## Report of Chief Executive Strategic Housing Development

APPLICANT: Dundrum Retail GP DAC

**DEVELOPMENT ADDRESS:** site incorporating the old Dundrum Shopping Centre known as Dundrum Village Centre (D14K3T7) and adjacent properties to the west of Main Street, Dundrum, Dublin 14

DLR/ABP REFERENCE: ABP-313220-22.

Figure 1 Extract of Block 1A,1B,1C (Zone 1) Plan at Second Floor (Drawing No. DD-GRID-01-02-DR-A-PL102; Rev. P01) with windows and balconies (in red) where undue overlooking is deemed to potentially occur given separation distances of less than 20m.

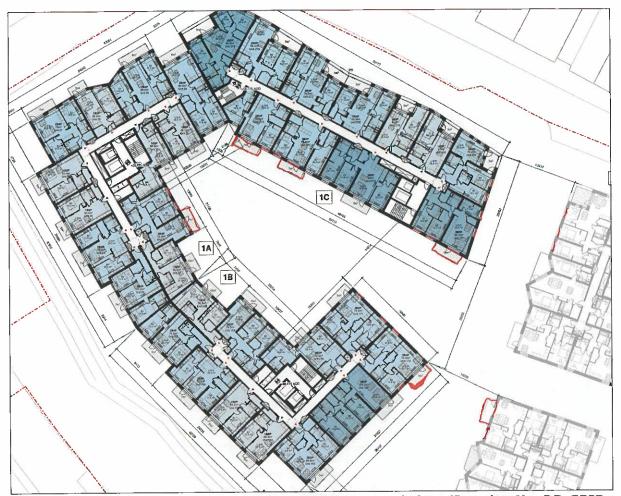
The Planning Authority is of the opinion that the subject scheme could lead to high levels of active and passive overlooking due to which many resident. Given the short distances involved, windows/balconies could be directly overlooked or will have the feeling of potentially being overlooked resulting in very poor levels of residential amenity. This issue would suggest that the proposal comprises overdevelopment of the subject site.

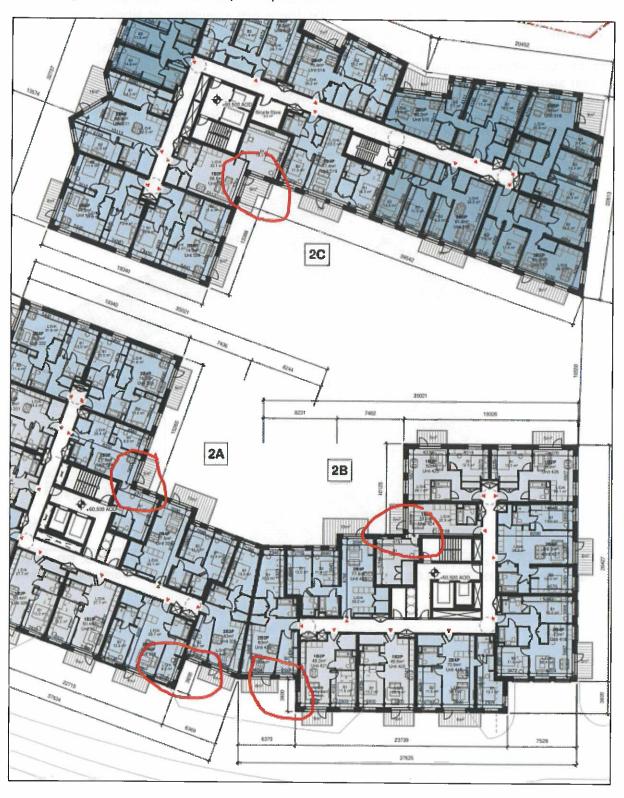
It is also noted that by increasing the number of 3-bedroom units could also assist in increasing the number of dual aspect apartments.

Figure 5: Extract of Block 2A,2B,2C (Zone 2) Plan at Third Floor (Dwg No. DD-GRID-02-03-DR-A-PL123; Rev. PL01) showing units considered by the Applicant as dual aspect. The image shows an example of apartments that the Planning Authority does not consider meet to meet the requirements to be deemed dual aspect (shown in red). There are many examples of that approach across the site that result in the Planning Authority having serious concerns as to whether 50% dual aspect units is being achieved as stated by the Applicant.

Figure 6: Extract of Block 1A,1B,1C (Zone 1) Plan at First Floor (Drawing No. DD-GRID-01-01-DR-A-PL101; Rev. PL01) showing two examples of single aspect north facing units.

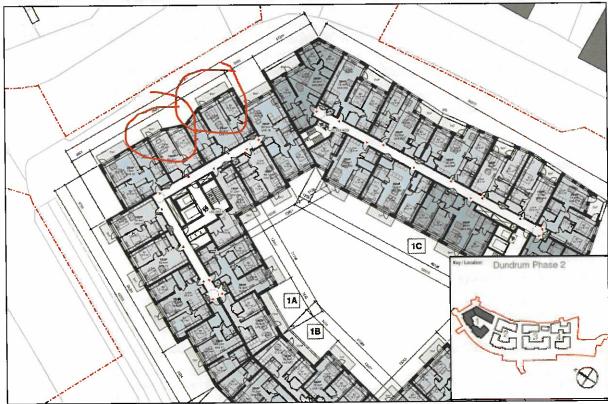
In terms of single aspect north facing units, the Applicant states that there are no such units within the proposal. The Planning Authority does not concur with that assessment. The planning Authority is of the opinion that there are a number of single-aspect north facing units (understood to be within a 45 degree angle either side of due north) across the development. According to the 2020 Apartment Guidelines, single aspect may be considered, where overlooking a significant amenity such as a public park, garden or formal space, or a water body or some other amenity feature. It is not considered that those circumstances where single aspect north facing units are acceptable arise as those units face the junction between Main Street and the Bypass or internal communal courtyards, which are not deemed of such quality to be deemed 'significant amenities'.

Figure 7: Extract of Block 2A,2B,2C (Zone 2) Plan at Third Floor (Drawing No. DD-GRID-02-03-DR-A-PL123, Rev. PL01) showing examples of single aspect north facing units. It is noted that as shown on the index map, the floor plan is shifted and north is to the left hand side of the image.

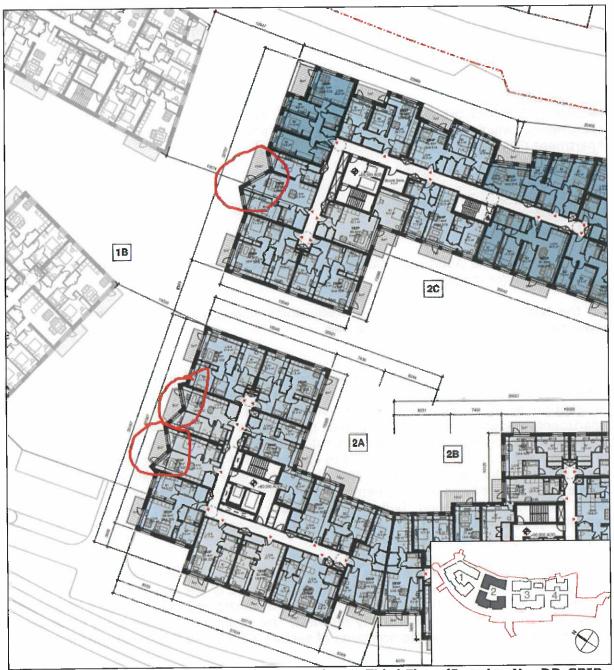
The Planning Authority is of the opinion that a number of units within the proposed development are not capable of providing satisfactory levels of residential amenity.
